INDESIT company

Model type:
AVXXF137FR

Commercial code:
F033720

n4008c02: Rear drum replacement

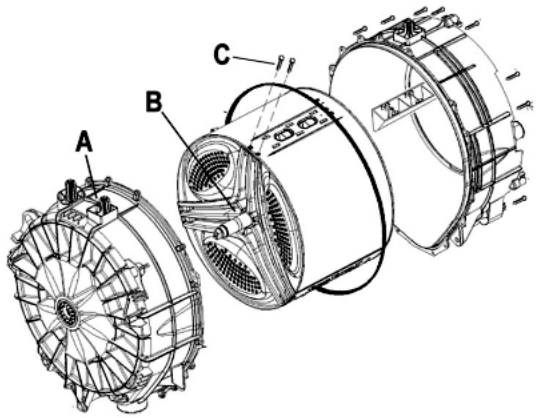
All drum service replacements use 35mm bearings

When you use in assistance the rear drum you will also need to change the drum bearing spider from the 30mm version to the 35mm version

A = C00119357 Drum Rear
B = C00117329 Drum Bearing Spider
C = C00201310 Drum Bearing Spider screws (Qty 6)

Please Note:

Production use 3 screws but for Service we suggest that 6 screws are used.

n0508c01: Door Gasket Clamp Band

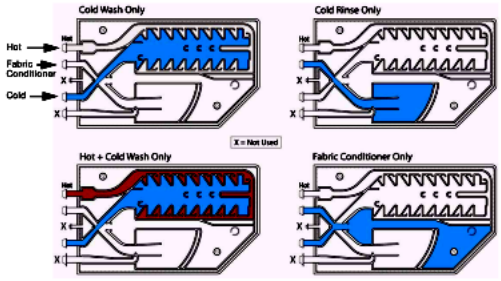
A New Polypropylene Gasket clamp band has been introduced in production from Serial number 80325.0000
The purpose is to provide added support to the inner rim of the door gasket.
